MULTISITE ROOFING 2016  
Kelly Middle School  
Willard School  
C.I.P. No. 450.780.209

ROBERTSON/SHERWOOD/ARCHITECTS pc  
132 E. Broadway - Suite 540  
Eugene, Oregon  
Project No. 1607

This Addendum forms a part of the Contract Documents and modifies the original Bid Documents dated April 13, 2016 as noted below. Acknowledge receipt of this Addendum in the space provided on the Bid Form. Failure to do so may subject Bidder to disqualification.

A  
ADI-1

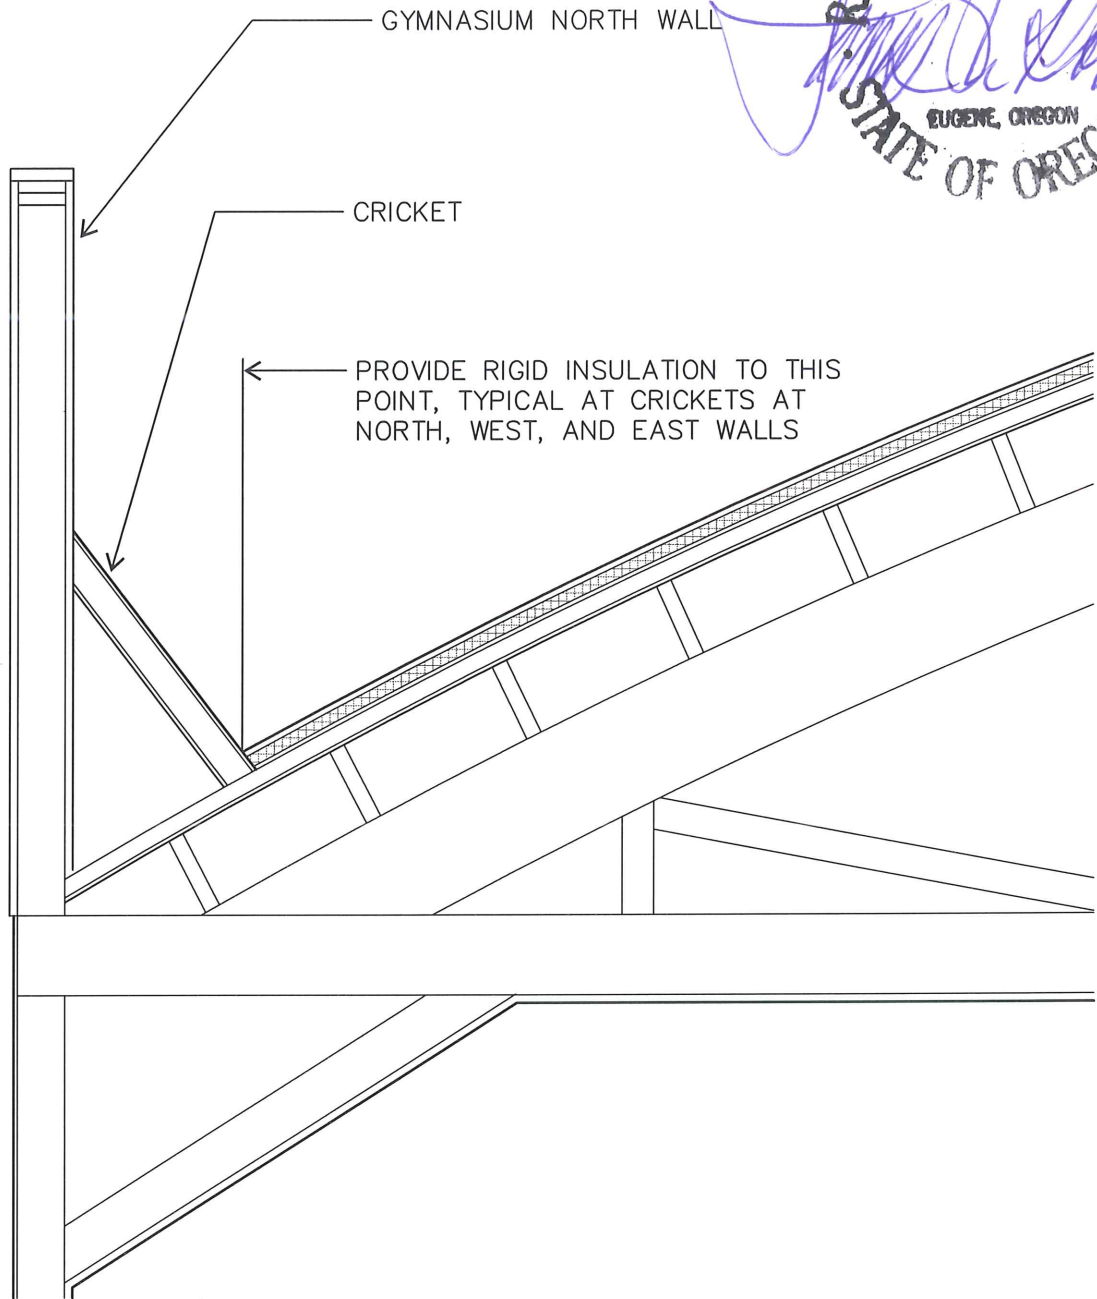
- A. Roof Types, Roof Assembly Type 1: Change thickness of ridged insulation from 1 inch to 1-1/2 inch.
- B. Kelly Middle School Roof Plan, B1/A1: Provide new rigid insulation to lower edge of crickets at north, west, and east walls. Refer to attached Detail Sheet AD1-1.
